ADDENDA: 01

Moore Station Expansion

Project Name: Moore Station Expansion Addendum 01
Addendum Date: August 8, 2022

S2

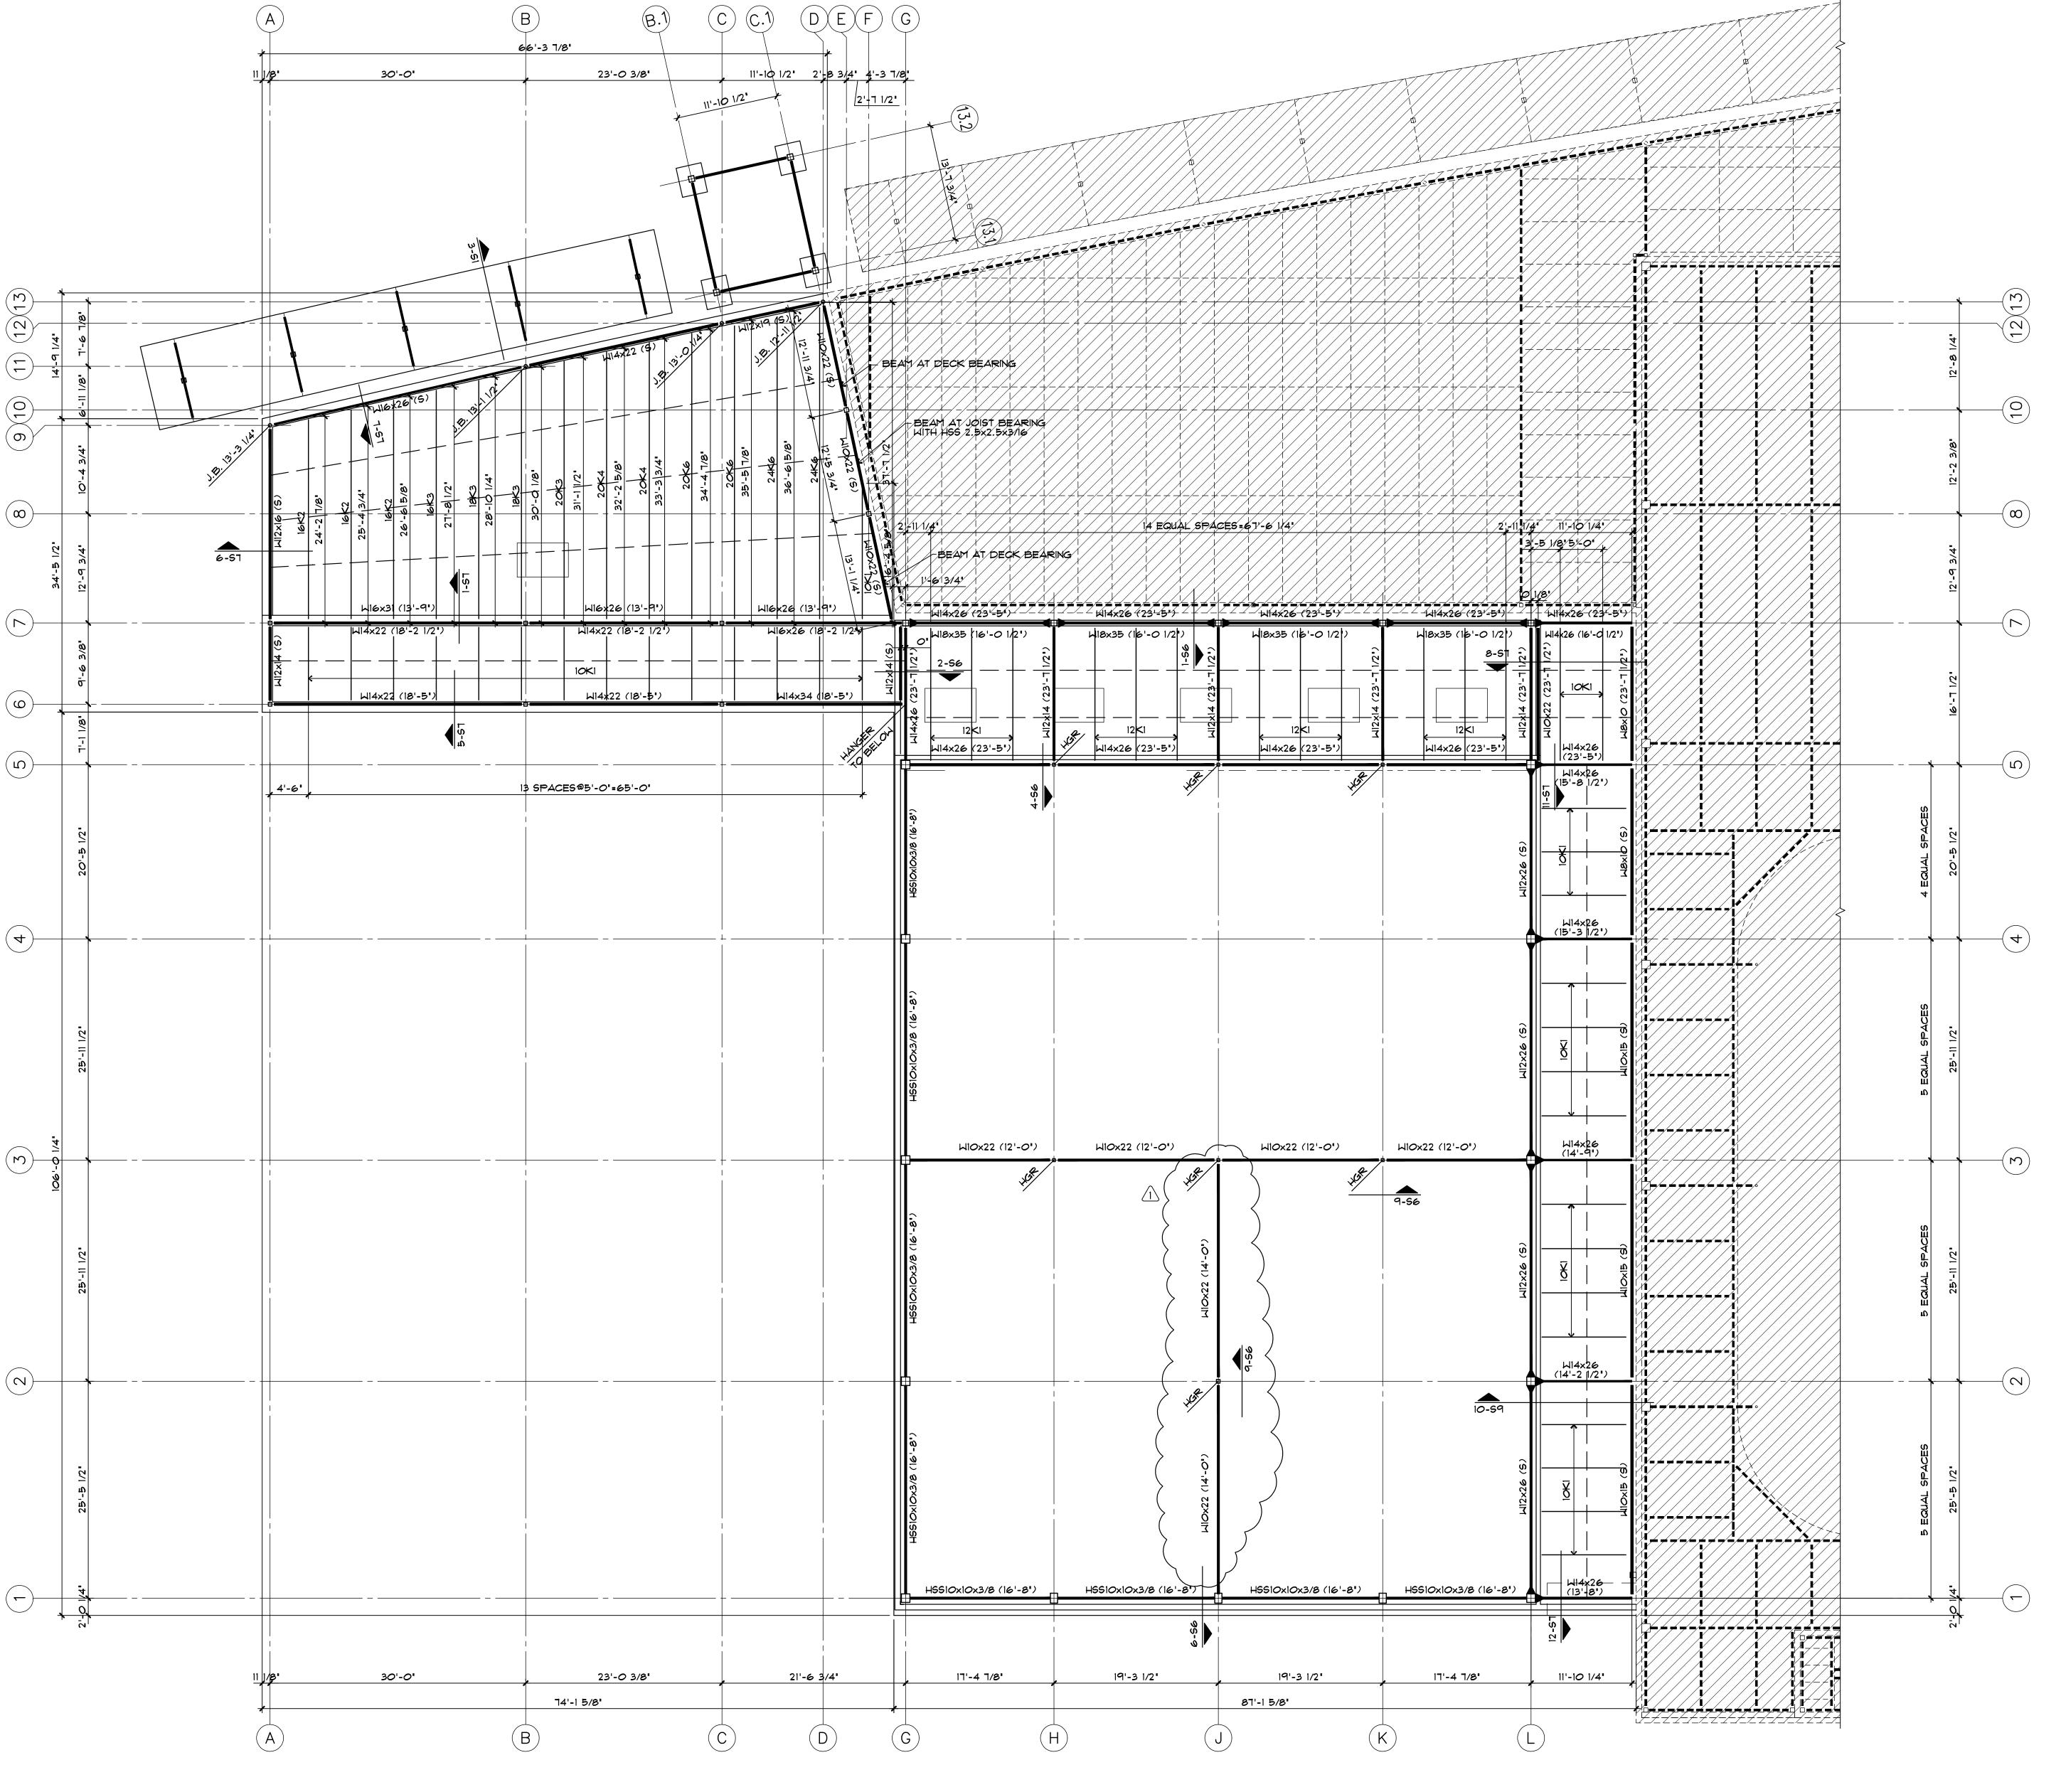
A1.6.2: Refer to S2 – Added Notes to indicate embed plates for

diagonal braces. Added section cut at slab recess. Added pier

caps at 7B, 7C, 5L, 4L, 3L and 2L.

S3

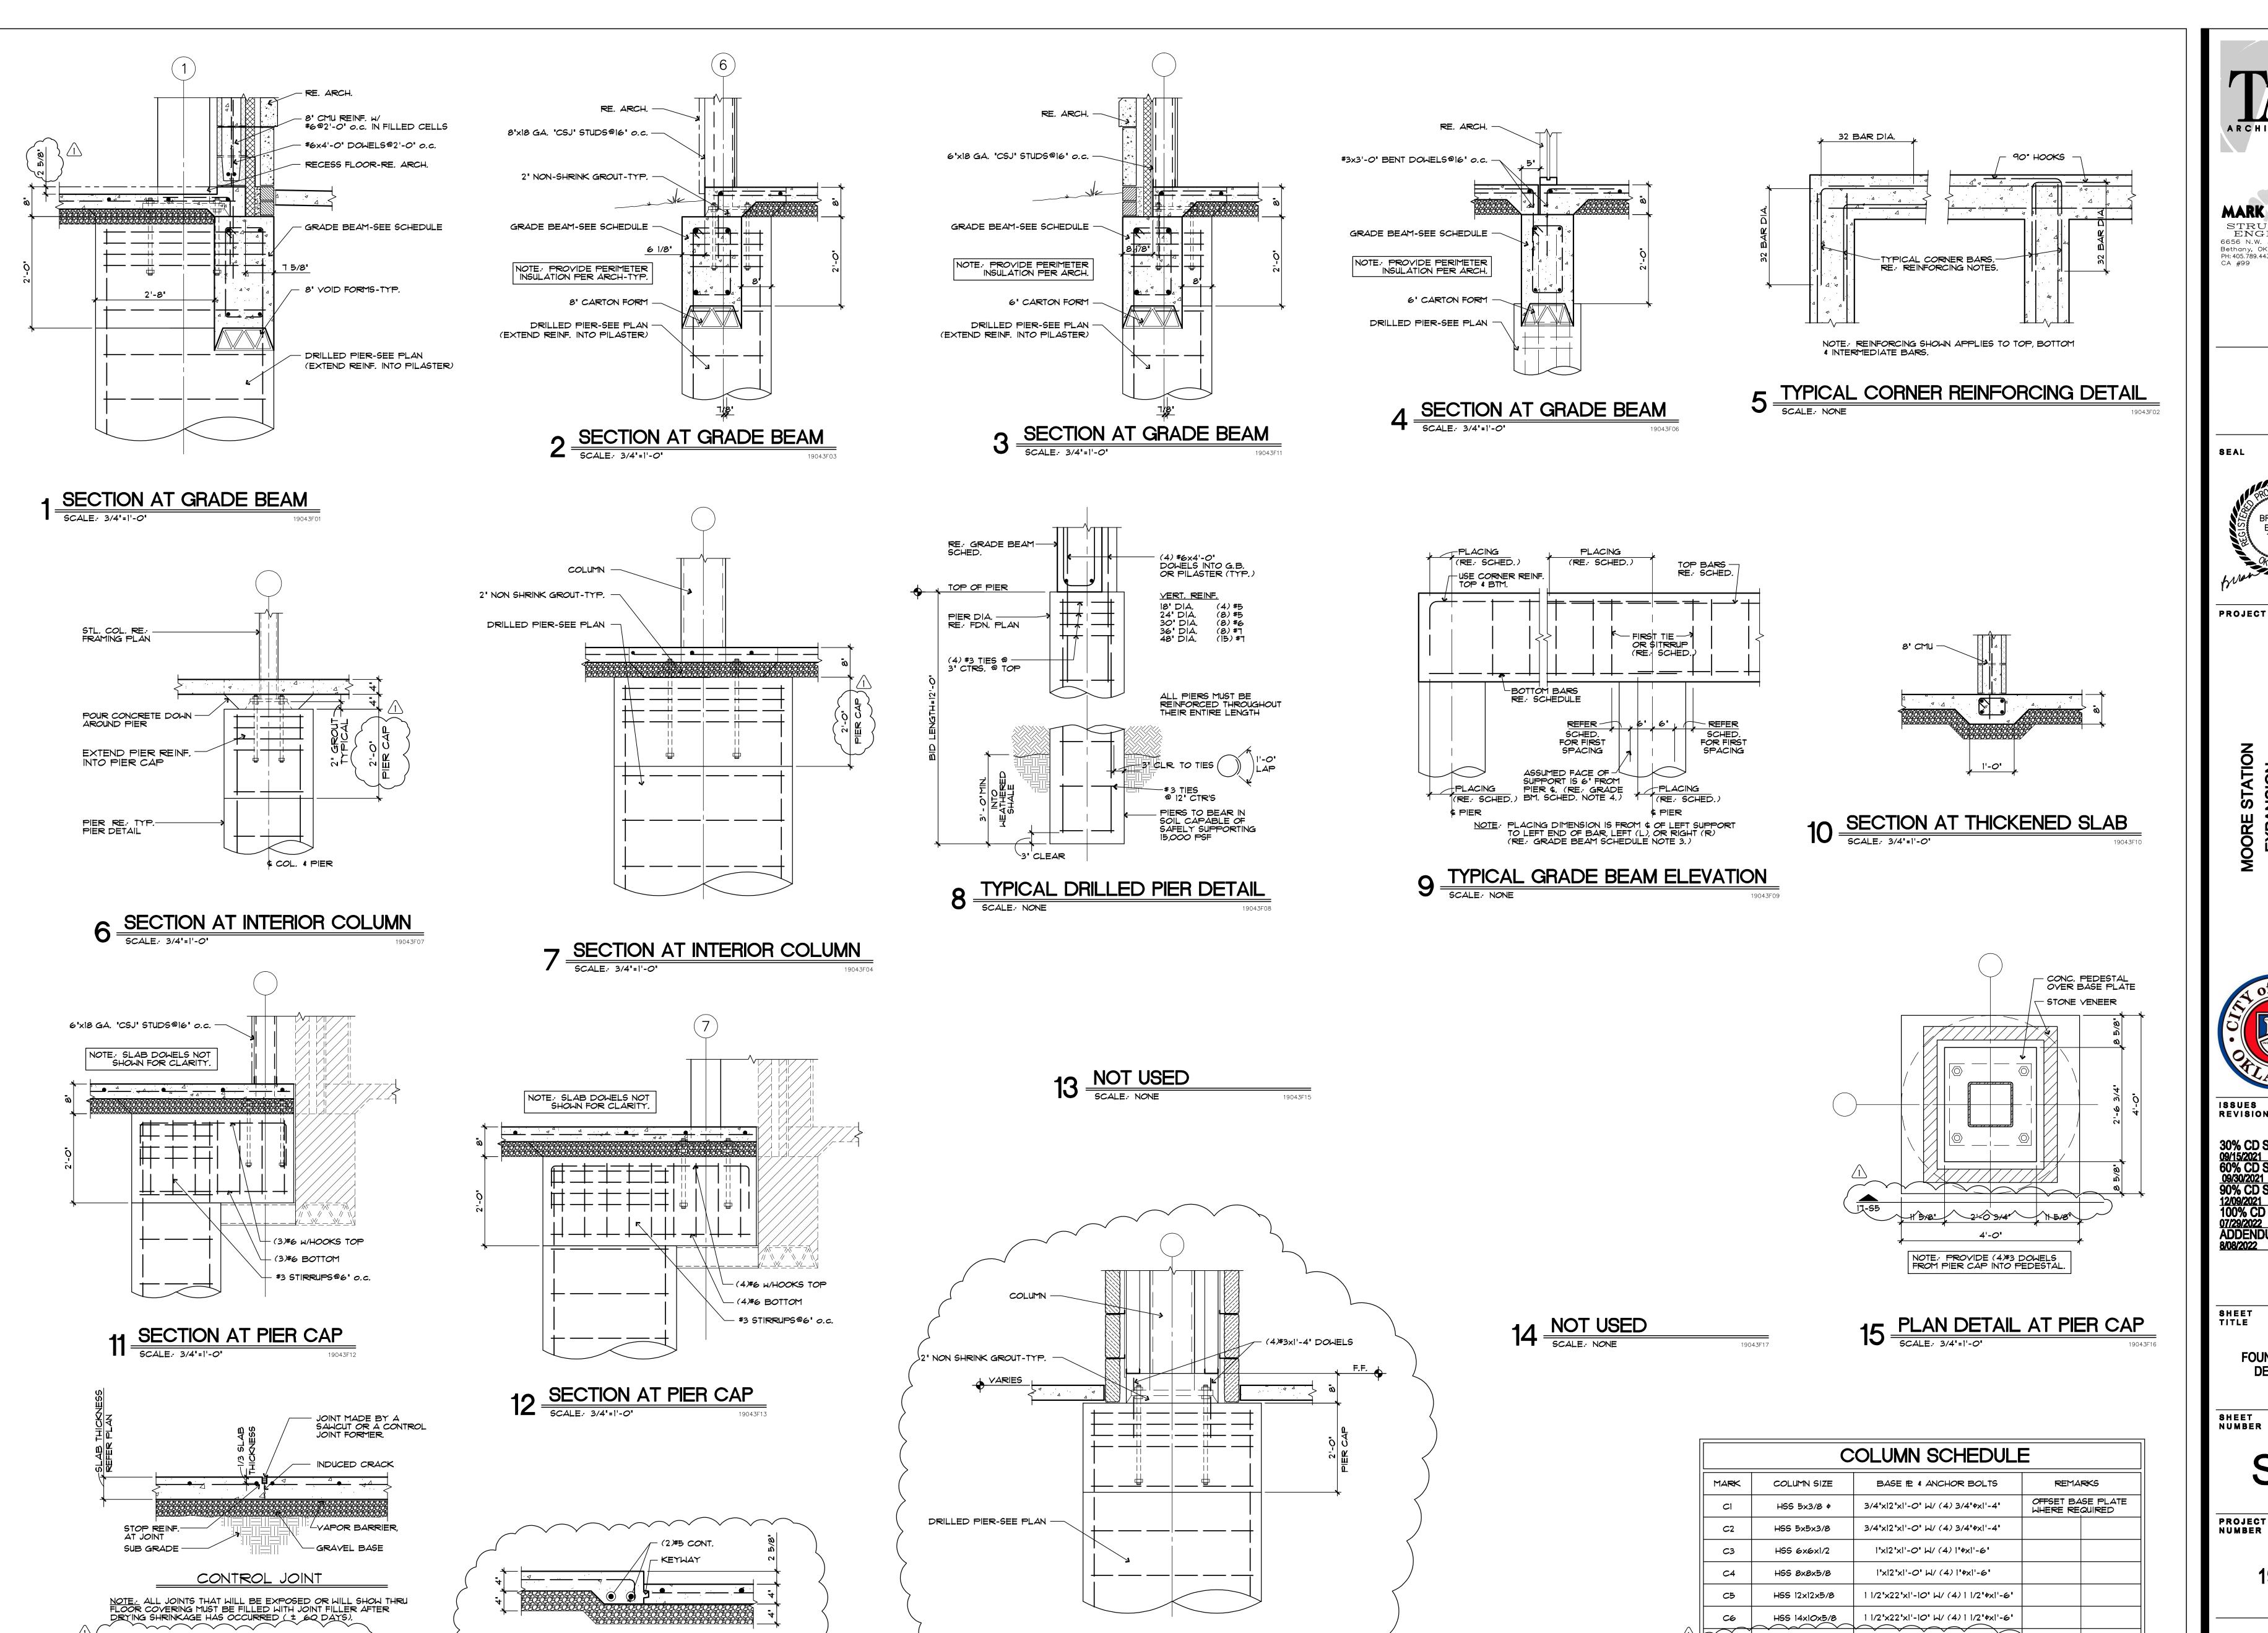
A1.6.3: Refer to S3 – Added partition supports at grid J.

FOUNDATION DETAILS

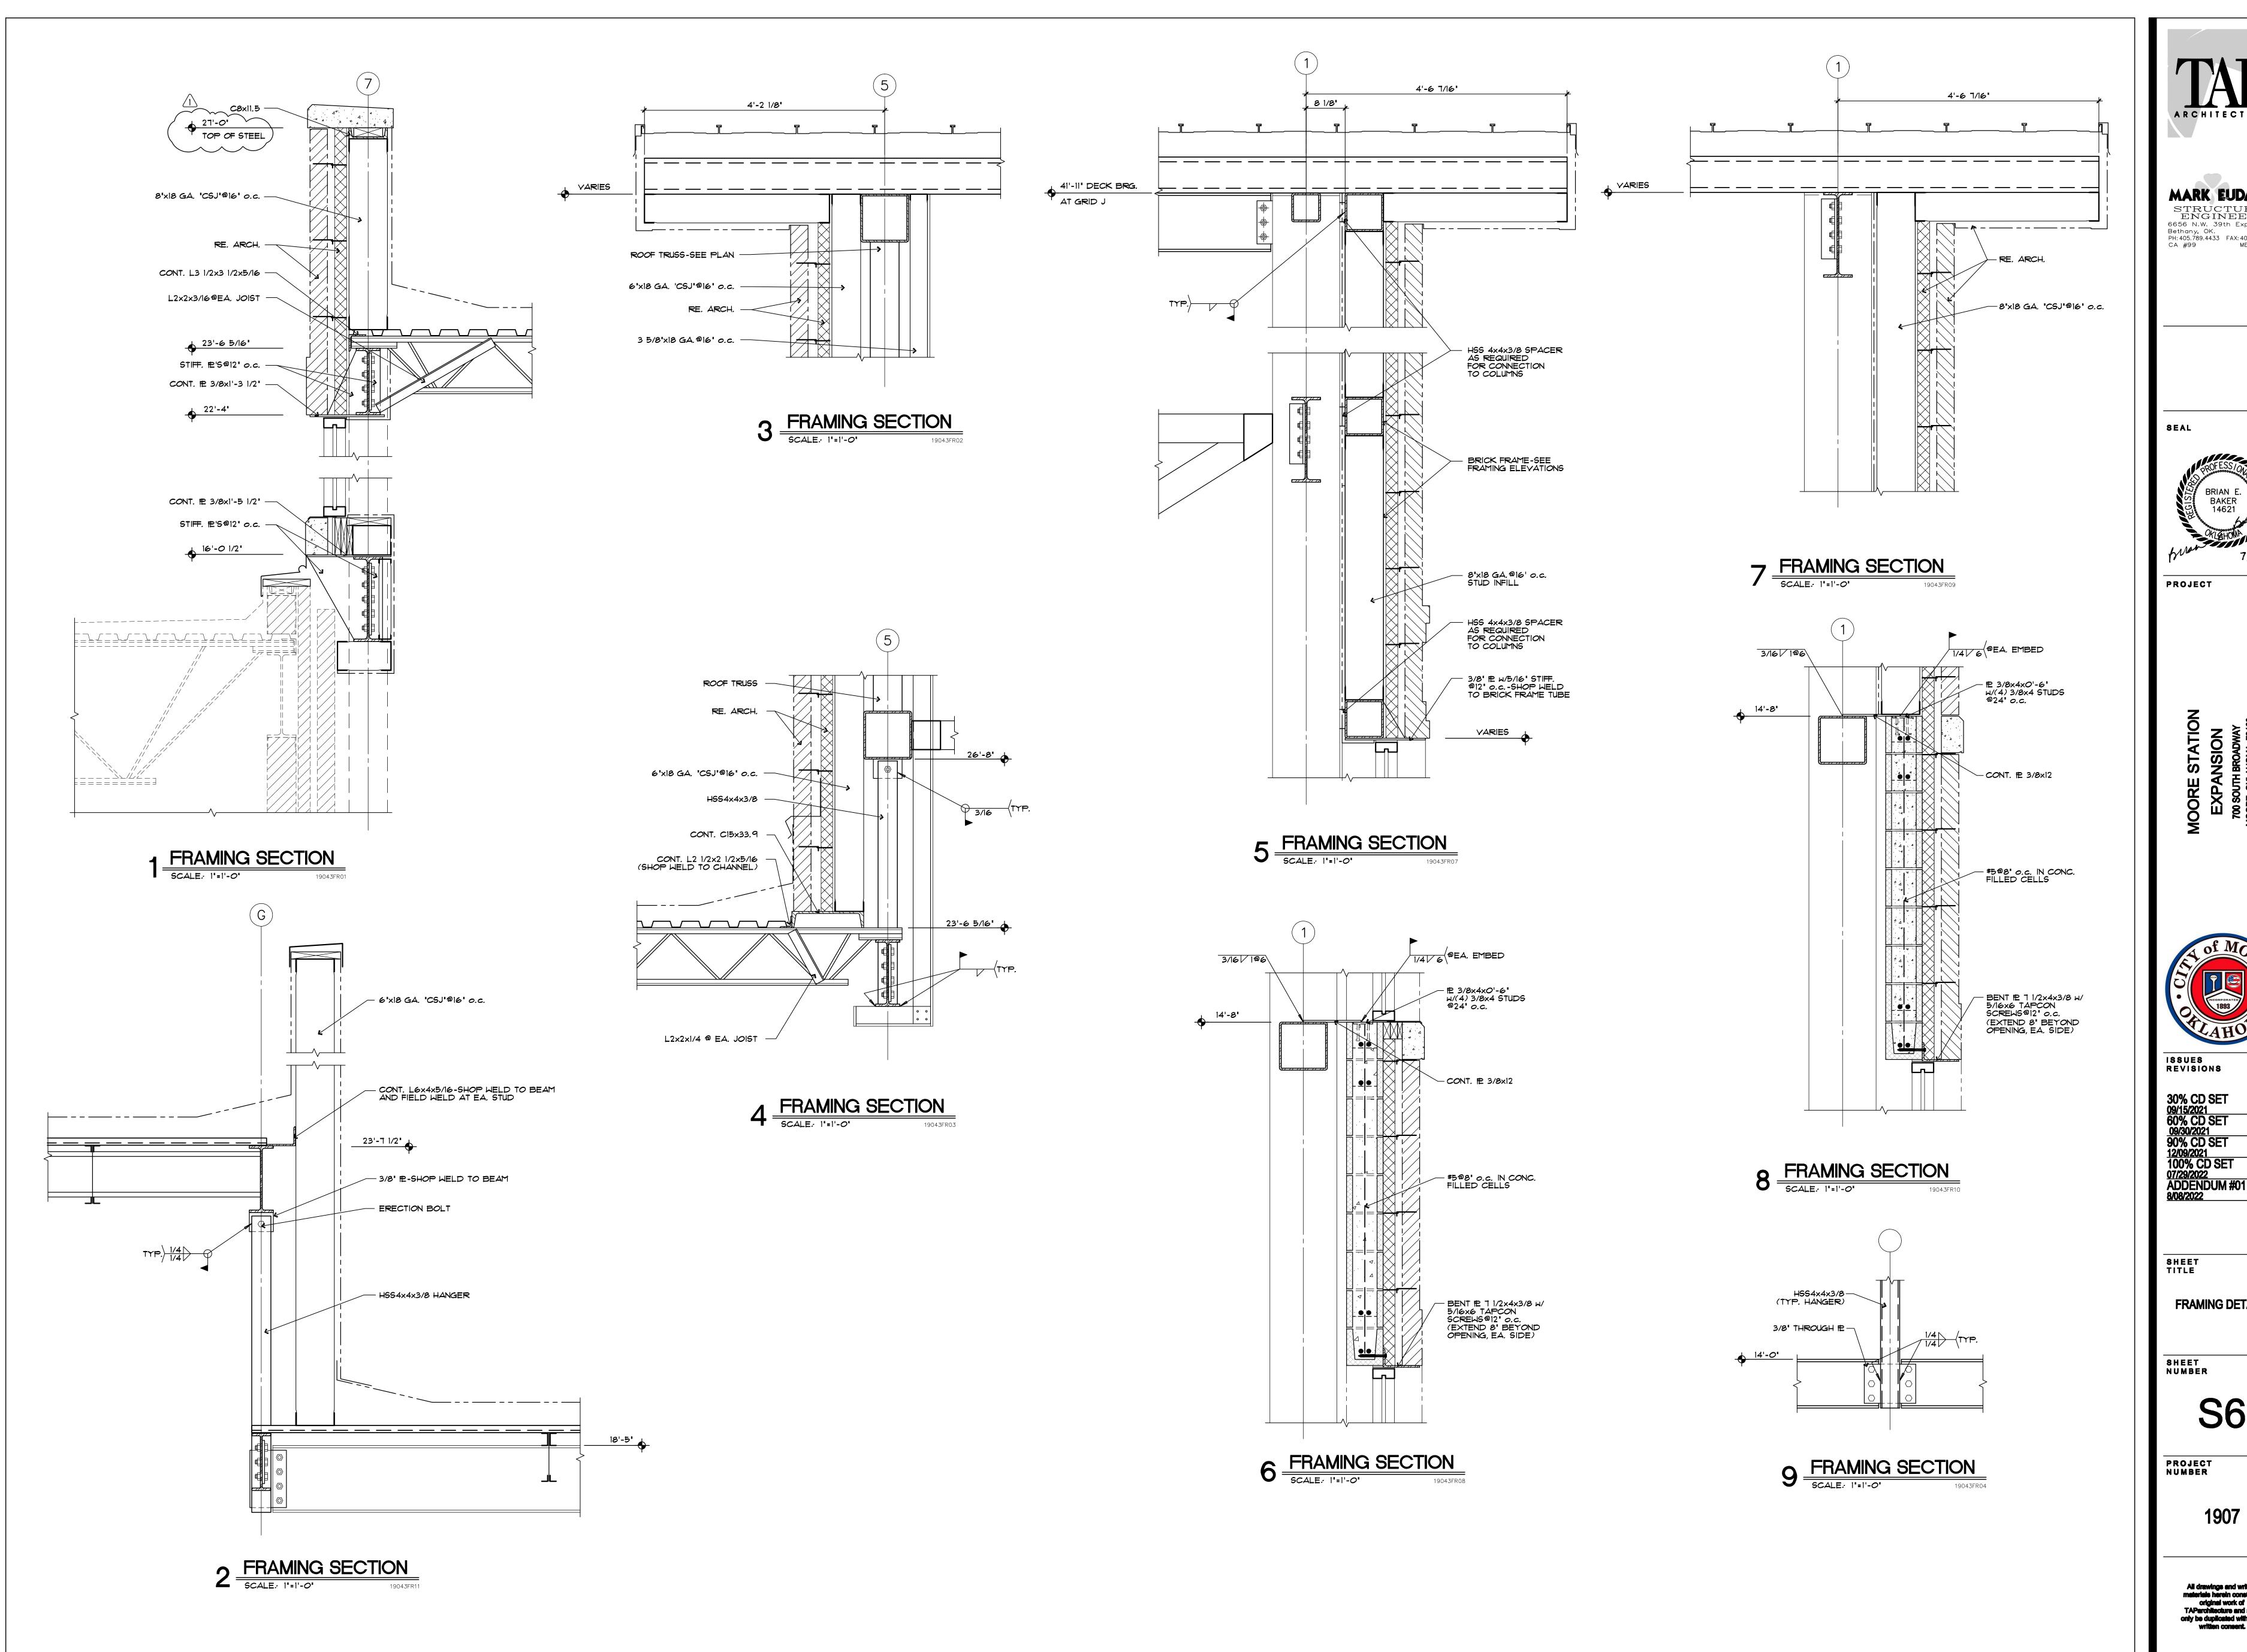
A1.6.4: Refer to S5 – Detail 1: Revised slab recess dimension. Detail 6:

Revised to show pier cap. Detail 7: Revised to show pier cap.

Detail 15: Added section cut notation. Detail 17: Added section for slab recess. Detail 18: Added detail for pier cap

clarification. Column Schedule added C7 notation.
